Remarks

The forgoing amendment has been made after a careful review of the present application, the references of record and the Office Action dated May 28, 2004. In the Office Action, the examiner required the applicant elect between three different species of the invention, the first as shown in Figs. 1 through 5, the second in Fig. 6, and the third in Fig. 7. The present Office Action was made following a conversation with Robert L. Marsh in which Mr. Marsh provisionally elected to prosecute the invention of Figs. 1 through 5. The applicant hereby confirms that the invention of Figs. 1 through 5 is elected to be prosecuted in this application.

FIG. 3

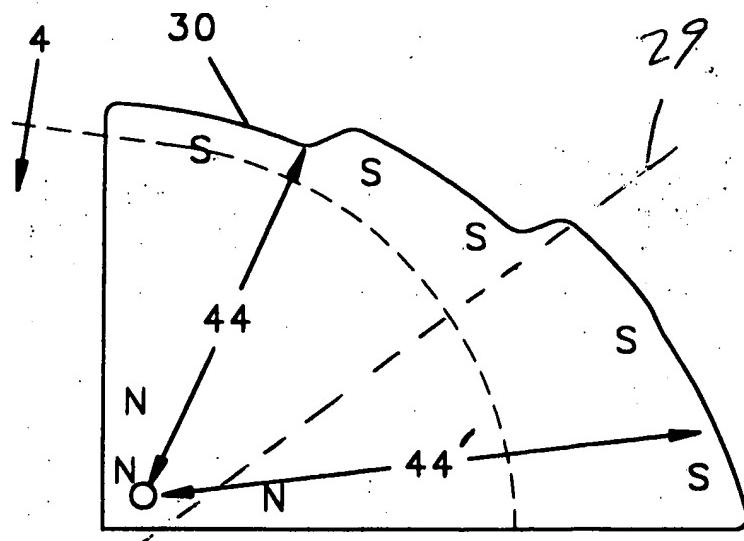
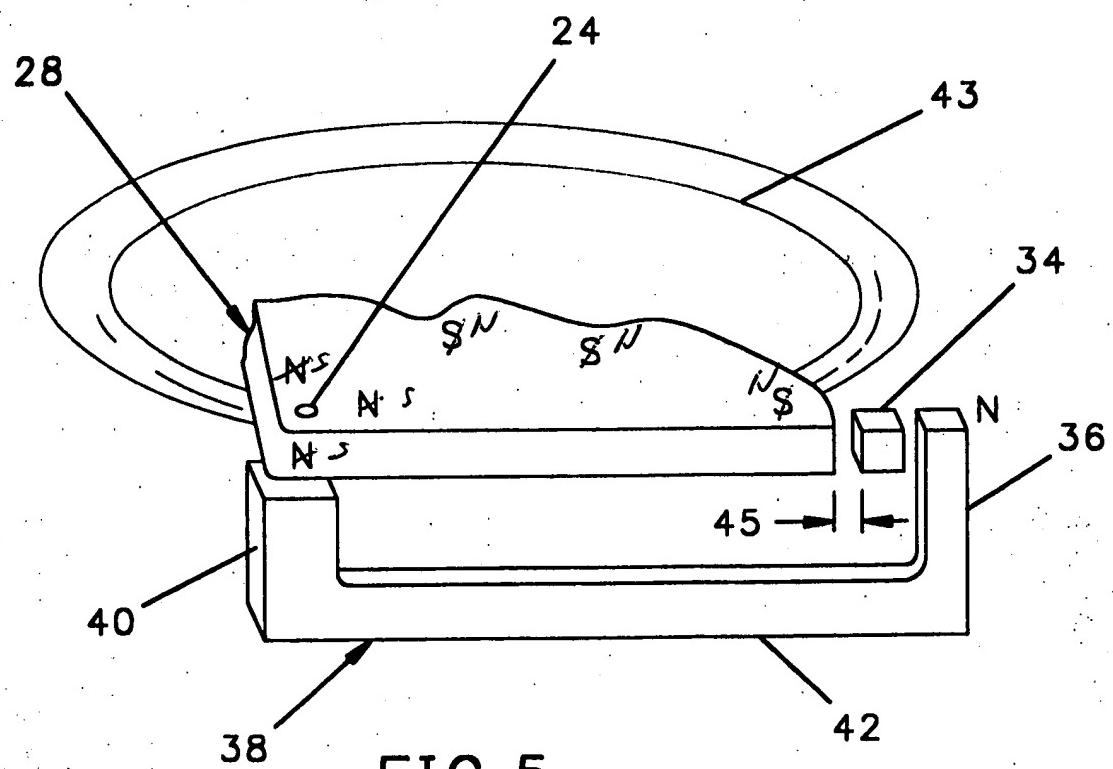
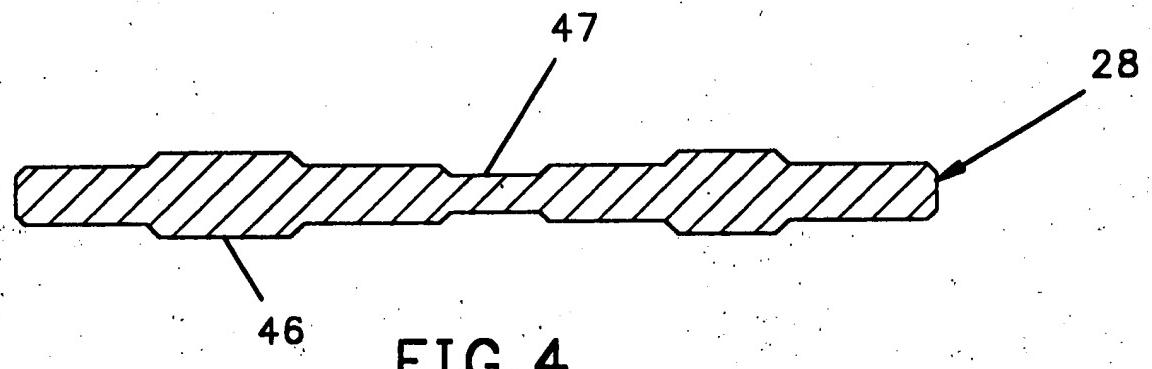
The applicant submits that the changes made to the drawings do not constitute new matter. The magnetic member has been described in the specification as having north and south poles as shown in the drawings. The direction of flux as emanating from the outer surface 30 is also discussed, as is the fact that the flux defines a circuit. Therefore, the addition of an “axis” extending generally between the poles, as has been added to Fig. 3, does not constitute new matter.

In the forgoing amendment, the applicant has amended the title as described above, and amended the drawings to overcome the objection noted by the examiner thereto. The applicant has also amended claim 1 and canceled claims 8 and 11 through 22. Claim 10 has also been amended and new claim 24 has been added. The remaining claims all relate to the invention shown in Figs. 1 through 5 of this application.
